TECHNICAL MEMORANDUM

SUBJECT: *Proposed Locations and Data for Construction/Calibration of Additional 1D Models (FINAL)*

ATTACHMENT A – RESPONSES TO GLMC COMMENTS

Figure 2
Locations of One-Dimensional
Compaction Models

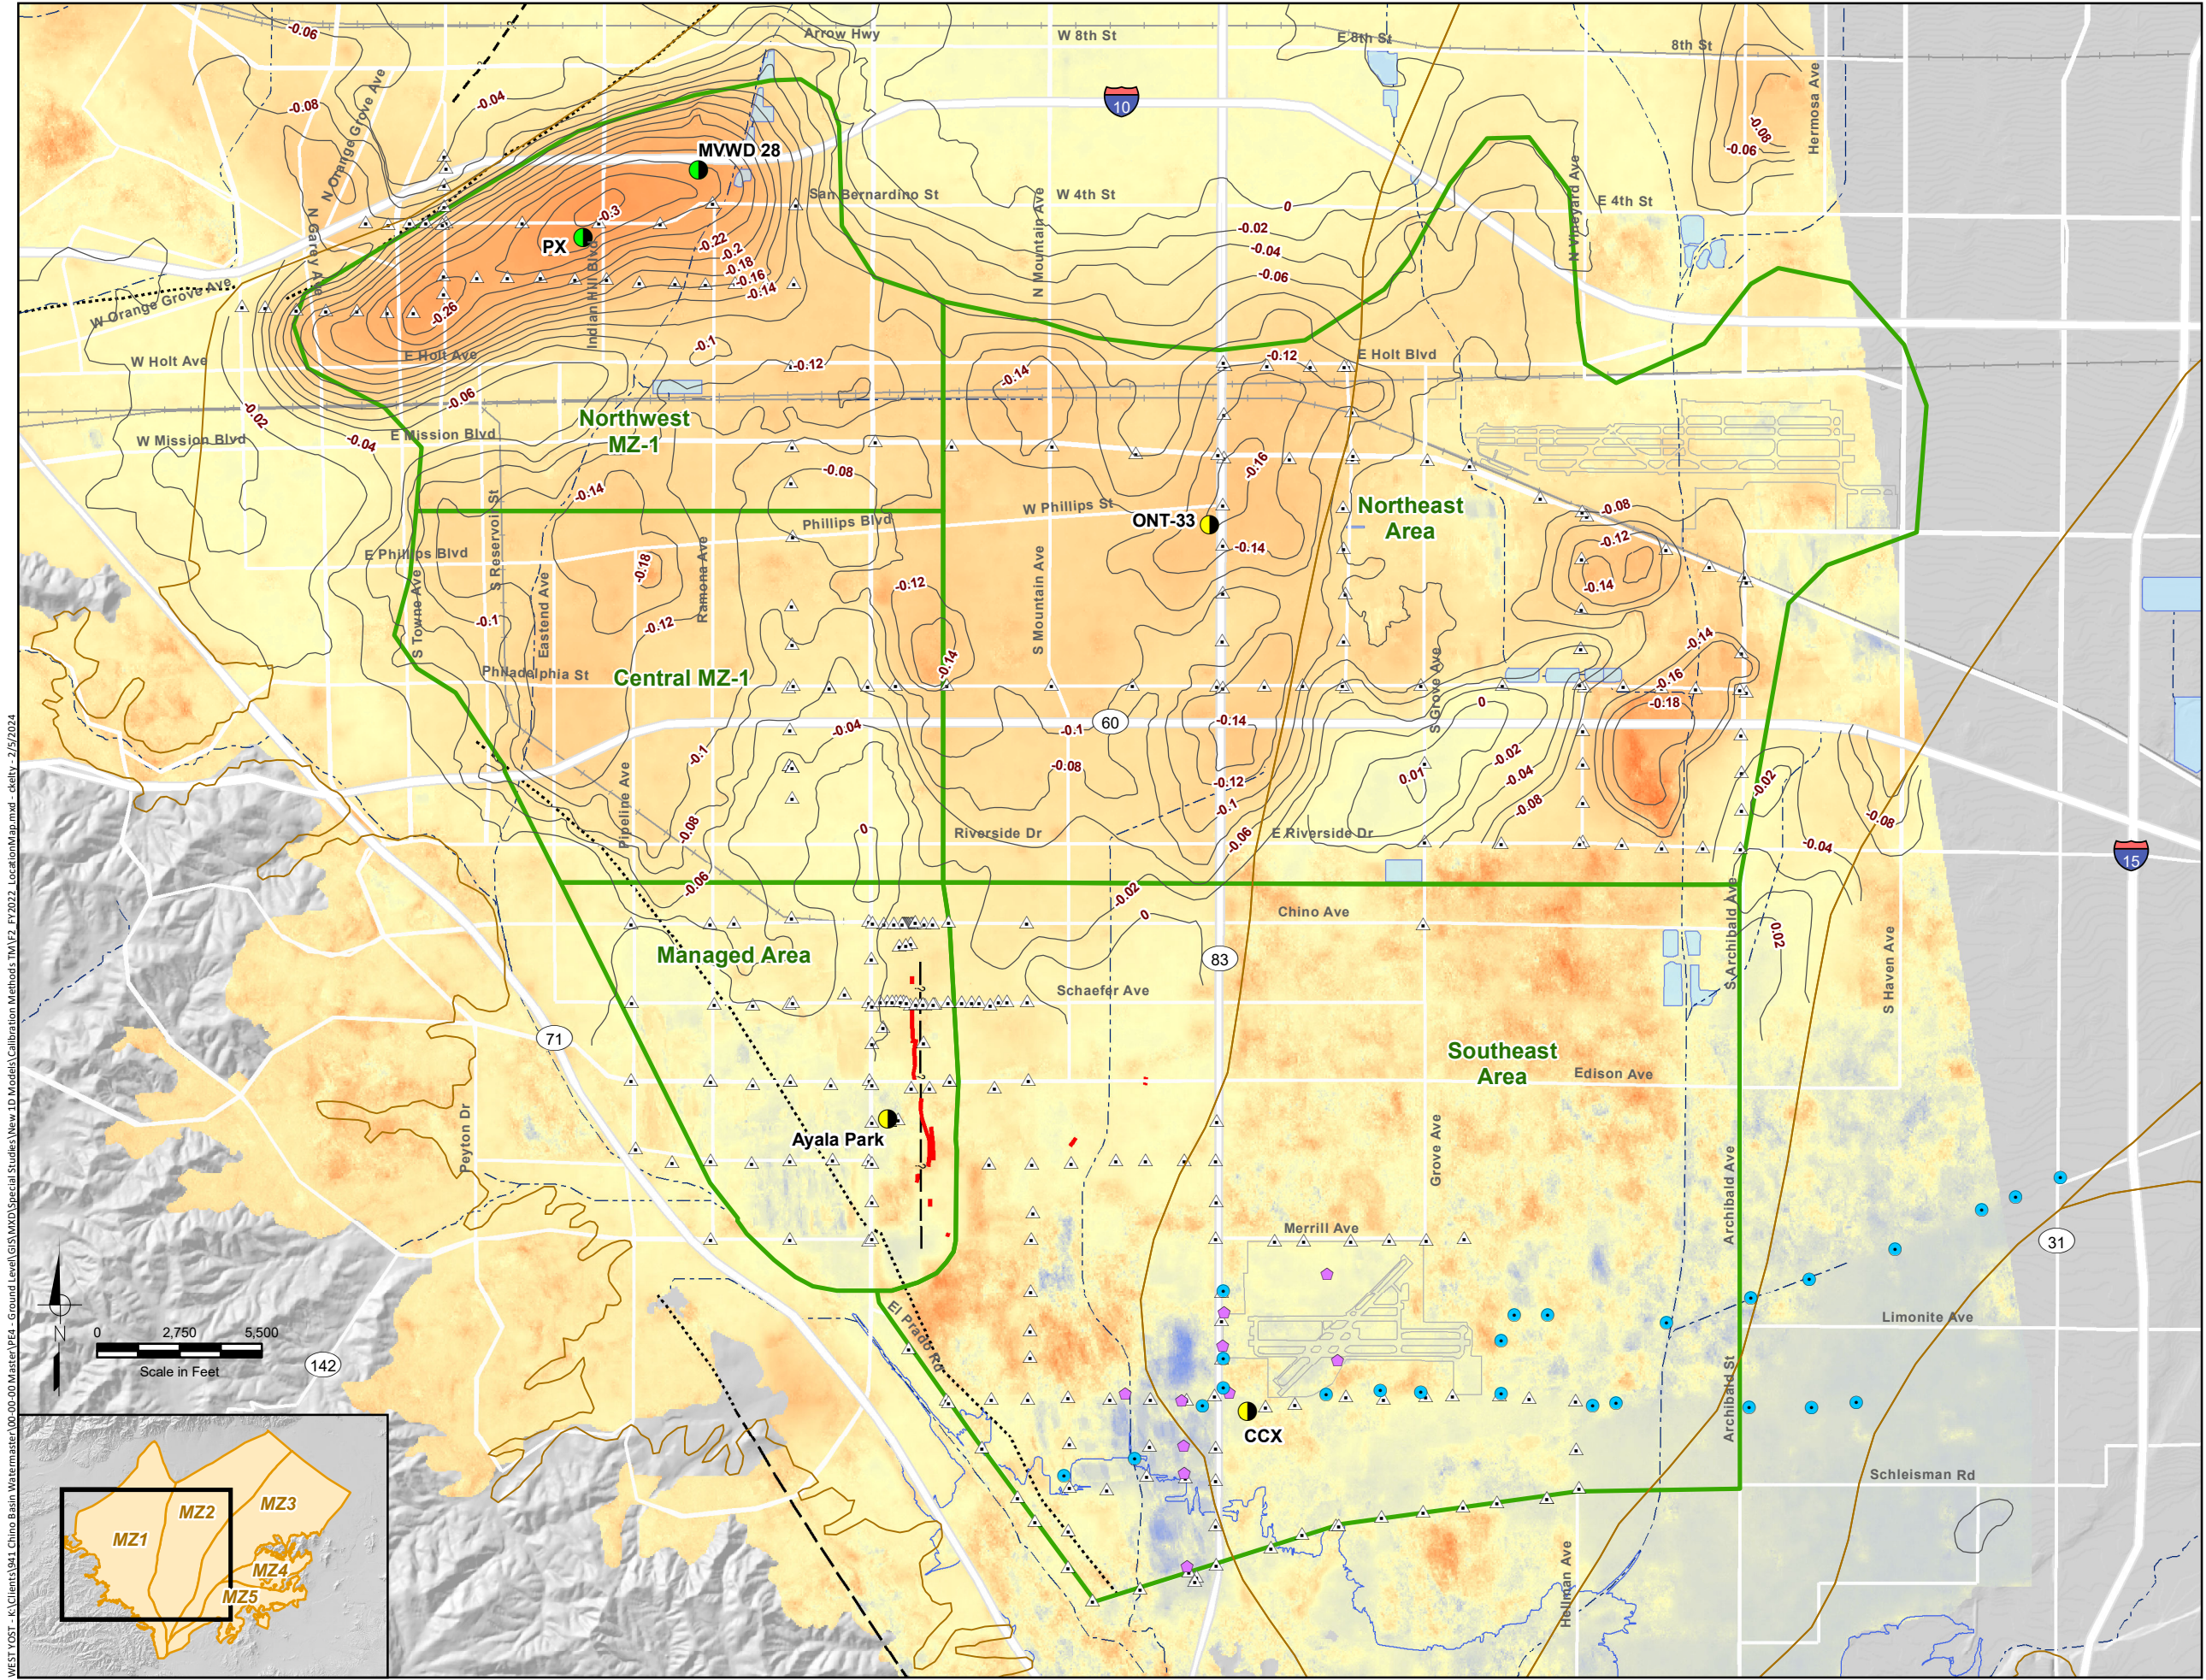
“This location was chosen because gradual and persistent land subsidence has occurred across this area since at least 1992, totaling over one foot at this location.”

The District recommends referencing a specific dataset over a specific period of time here. If the dataset has been gap-filled, the District recommends excluding gap-filled time periods from the description.

Also, are patterns of differential subsidence observed at this location?

It is logical and scientifically defensible to estimate the rate of subsidence for the time gap in the InSAR data at the Ontario Well 33 location. The estimated rate of subsidence during the gap can be useful during model calibration. The rate was based on: (i) the rates of subsidence that occurred prior to and after the gap in the InSAR data and (ii) the measured groundwater elevations at wells in the area during the gap.

Regarding differential subsidence, it does not occur at a specific location, rather it is a spatial pattern of subsidence across an area. The InSAR data on Figure 2 displays patterns of differential subsidence observed near Ontario Well 33 and across the Northeast Area.

Figure 4

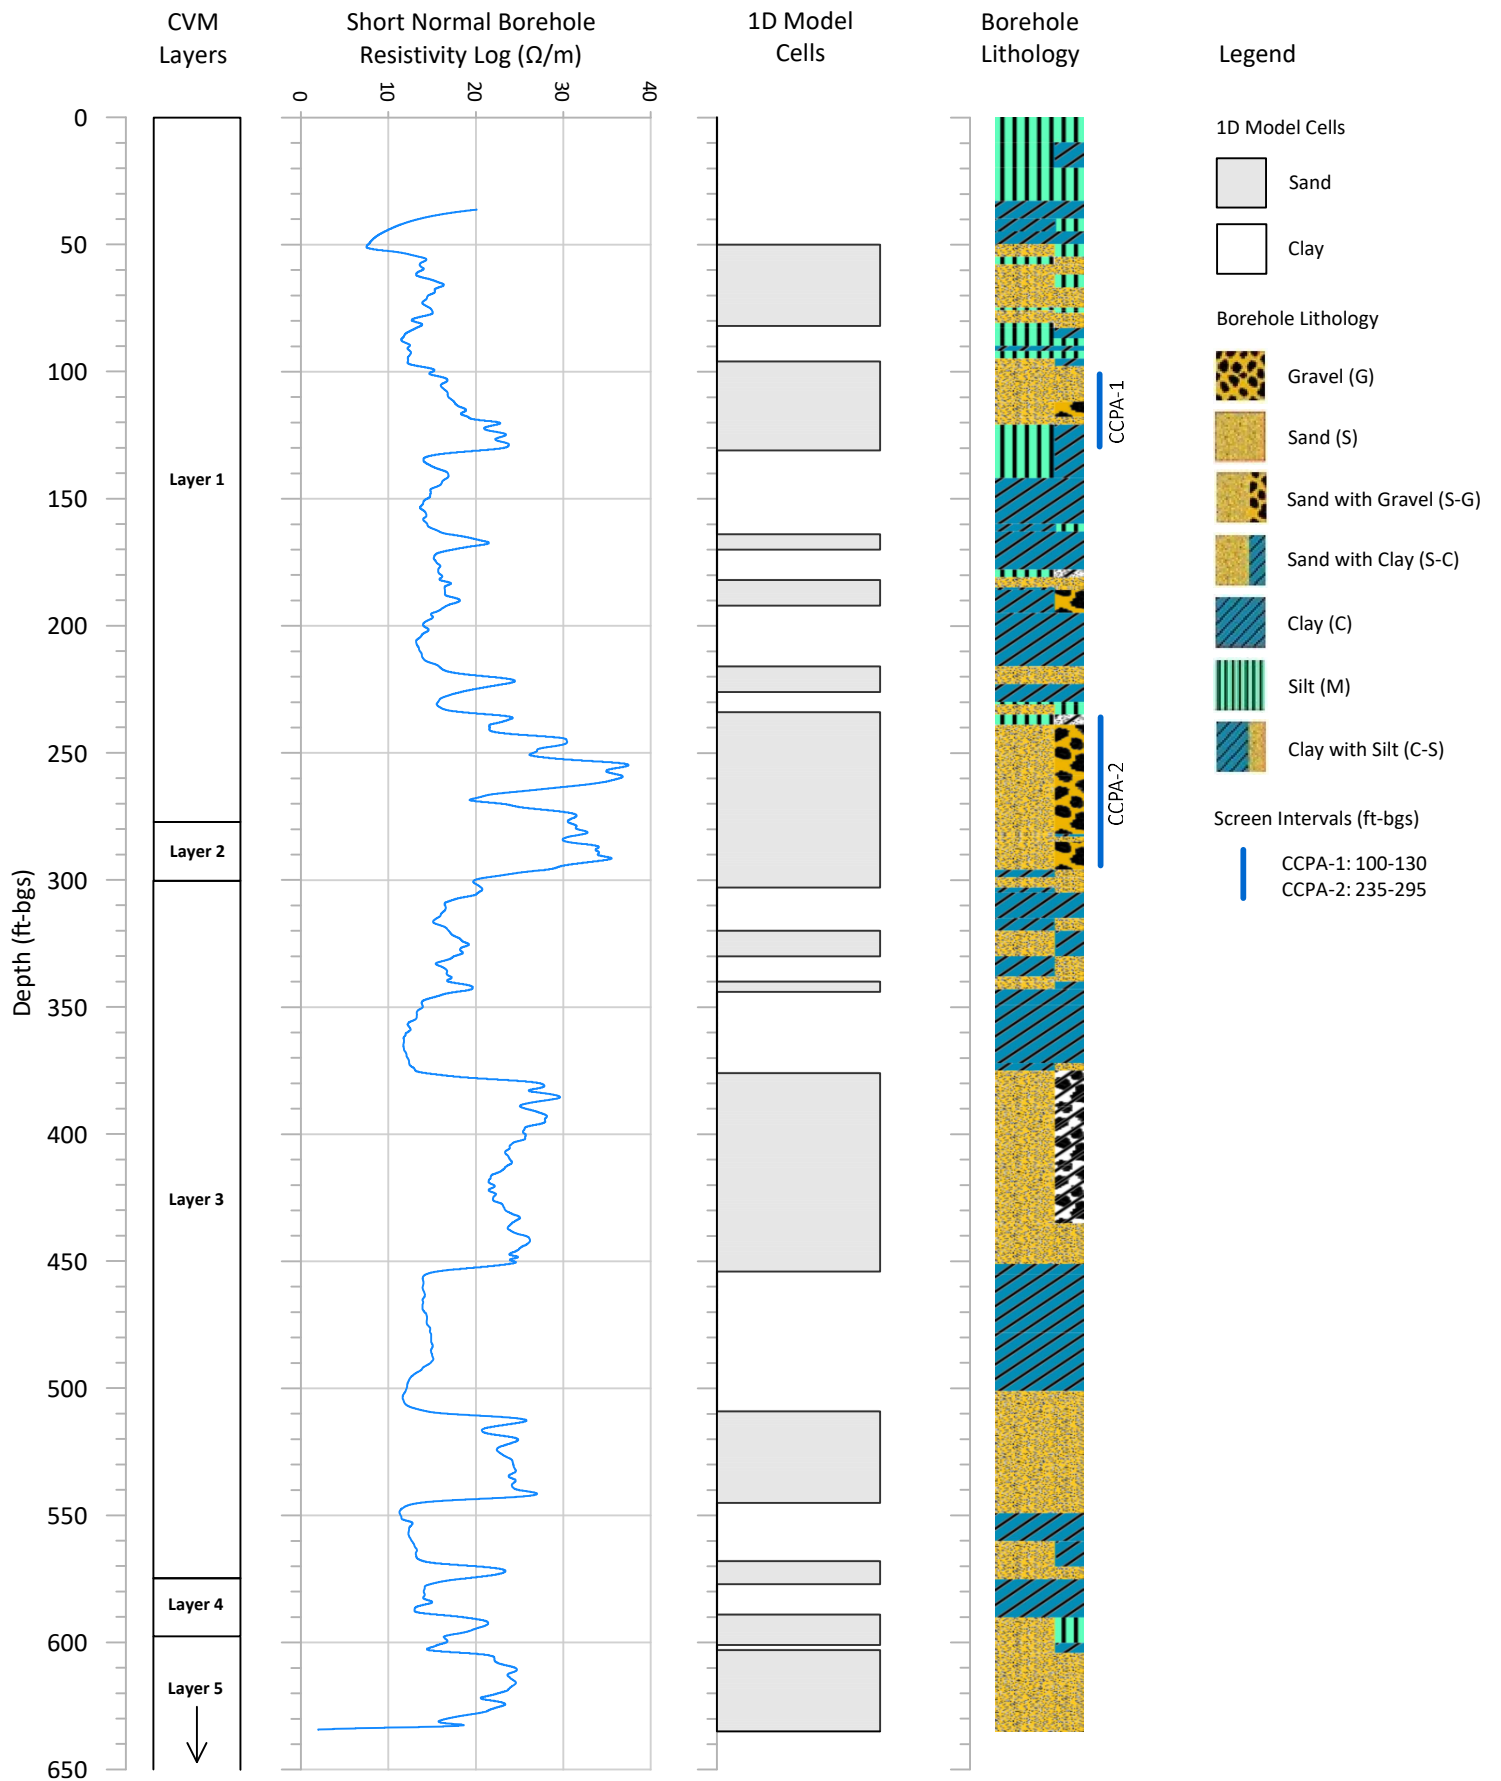
Figure 4 InSAR Time Series.

How were data gaps in the InSAR addressed to develop the graph of total subsidence? Were the data gaps (pre-2005) filled by trend projection?

Also, is the InSAR data supported by other vertical ground motion data in this area?

The rate of subsidence at the Ontario Well 33 location was based on the rates of subsidence that occurred prior to and after the gap in the InSAR data.

There is a paucity of other historical data for vertical ground motion in this area to support the InSAR data. However, the GLMP has shown that InSAR data are supported by leveling surveys and extensometer measurements in Northwest MZ-1 and the MZ-1 Managed Area.

Figure 6

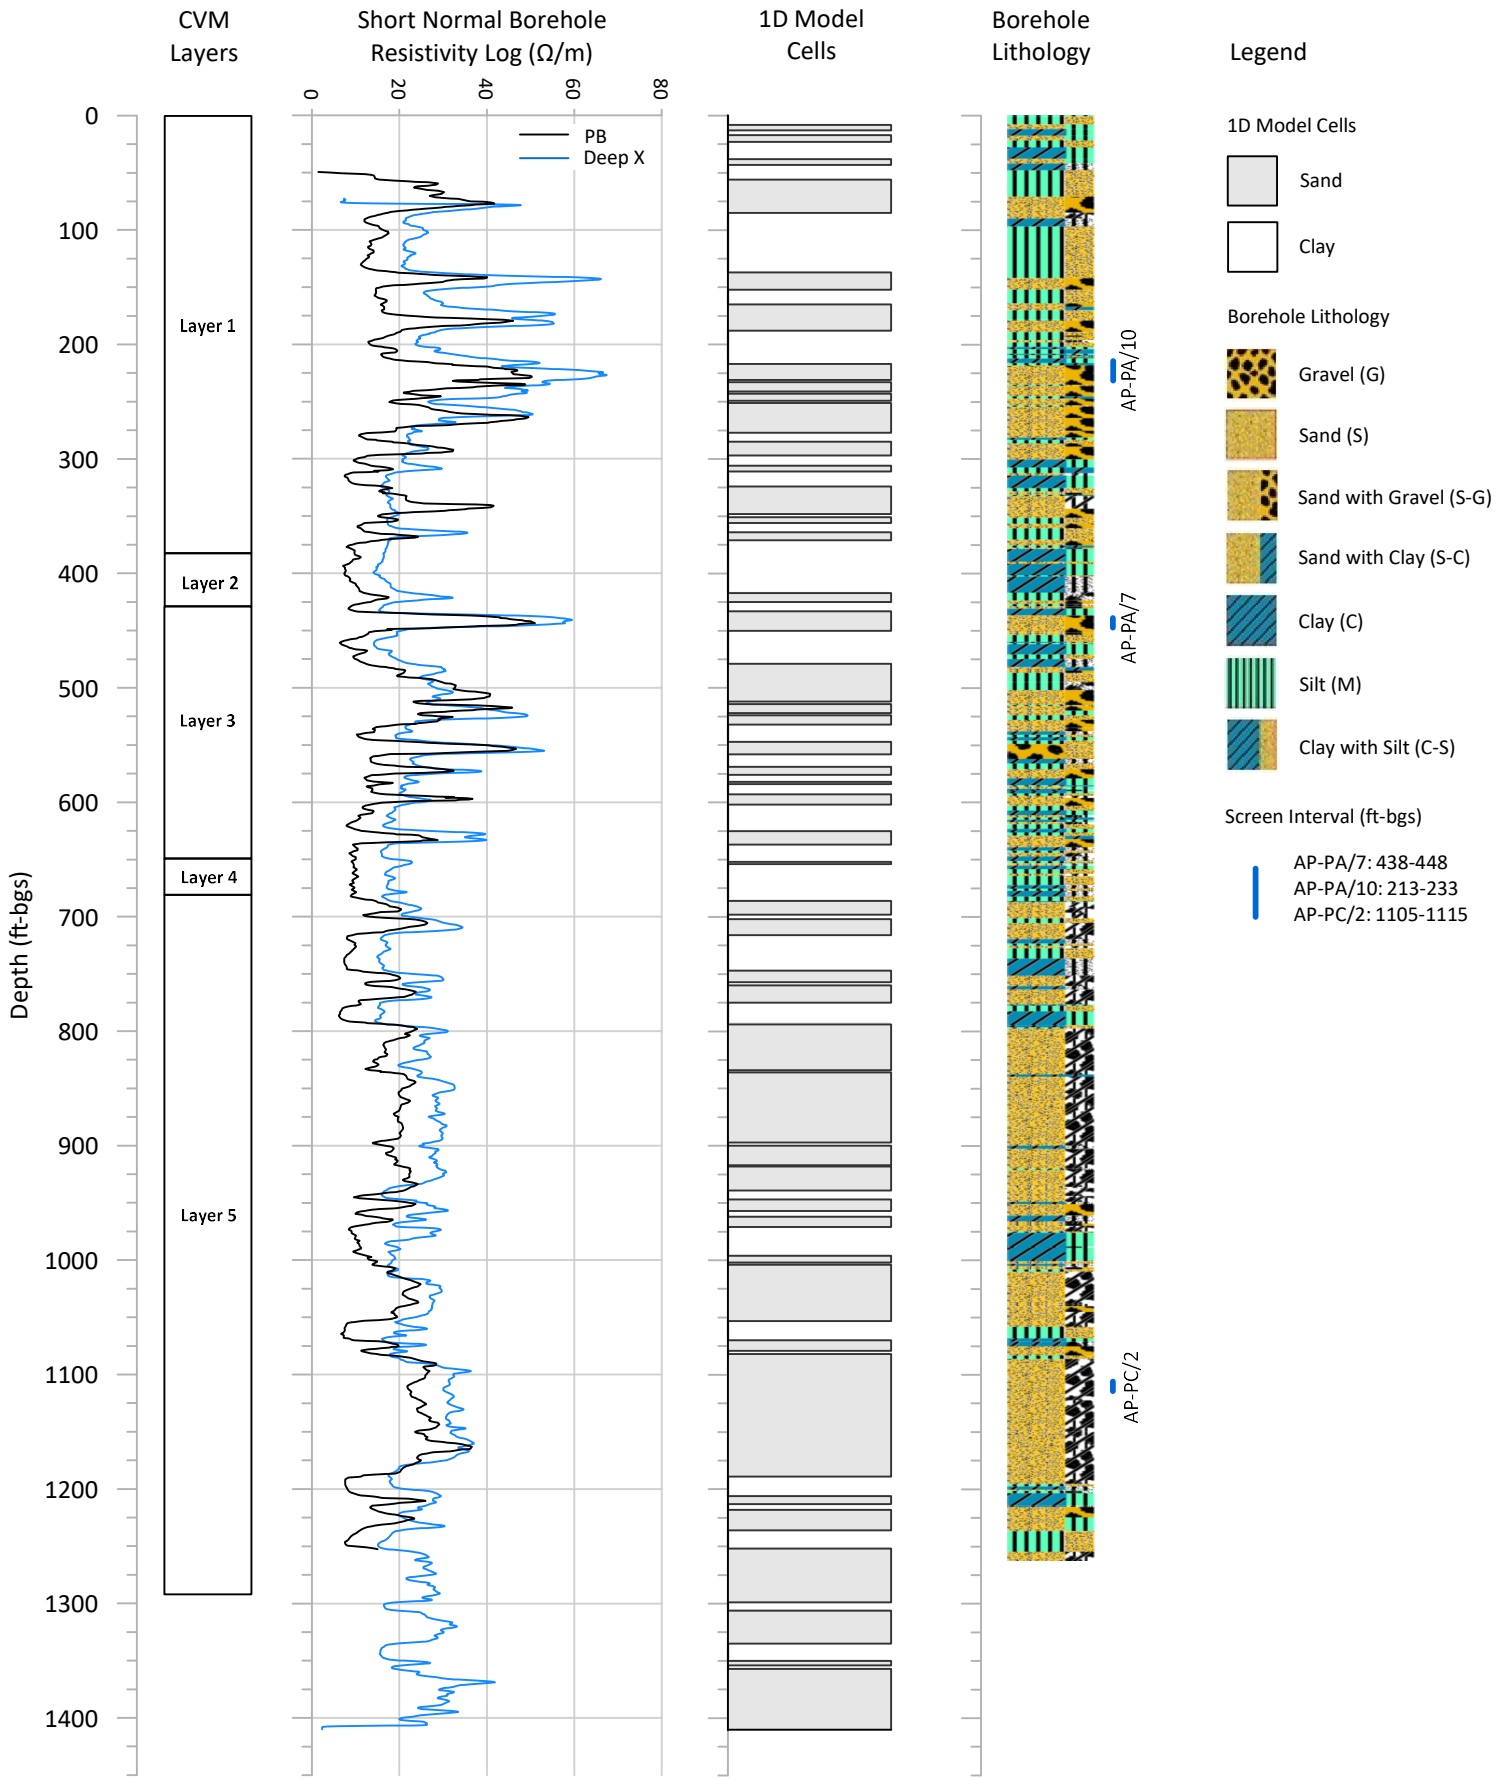
For the Ontario Well 33 model and for the CCX model, has research been completed on available ground leveling surveys (“traditional surveys”) in the area that could be used for additional calibration? Considering that hydraulic heads from 1930 to 2022 will be used in the calibration, ground leveling data prior to 1992 should be compiled and utilized.

Yes. The available ground level survey data near the CCX that will be utilized during 1D Model calibration is shown on Figure 6. There is no similar ground level survey data known to exist near the Ontario Well 33 location.

Figure 8

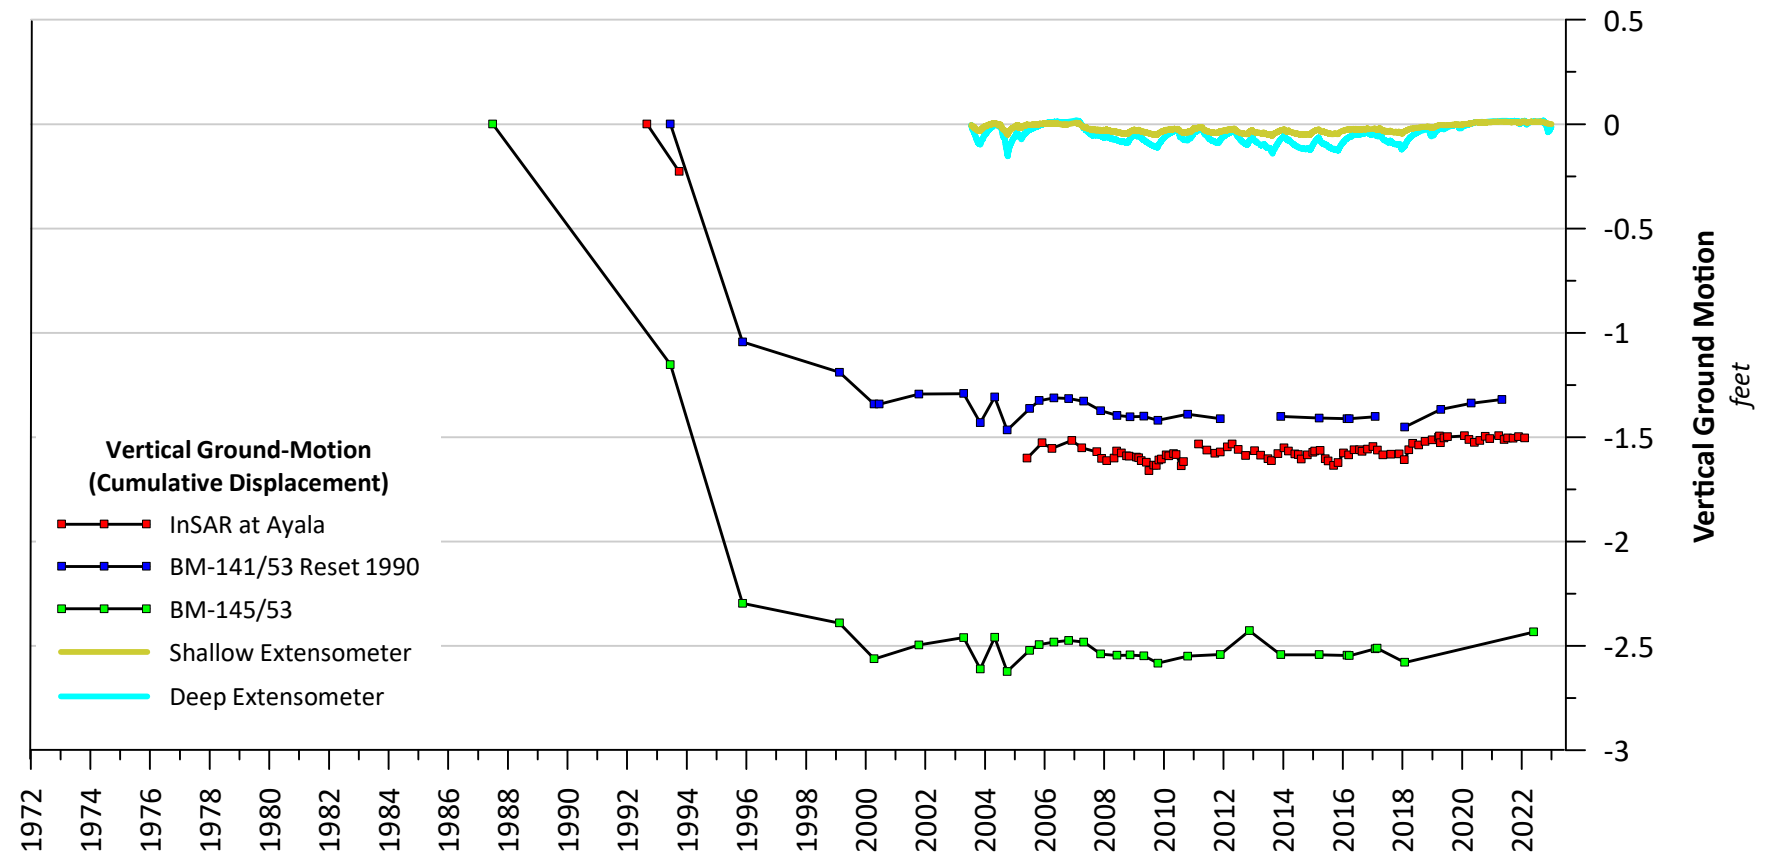
For the Ayala Park model, a description of the prior 1D compaction model should be provided along with descriptions of lessons learned from this past modeling exercise and how the model will be updated. Additionally, ground leveling data prior to 1992 should be compiled and used in the calibration process.

The prior 1D Modeling work at Ayala Park that was performed in 2006 was never documented, and hence, cannot be provided. A tremendous volume of high-resolution head and extensometer data has been collected since 2006, and we have made the decision to construct/calibrate a new model from the available data, instead of updating the old model. The ground level survey data that will be used in model calibration is shown on Figure 8.
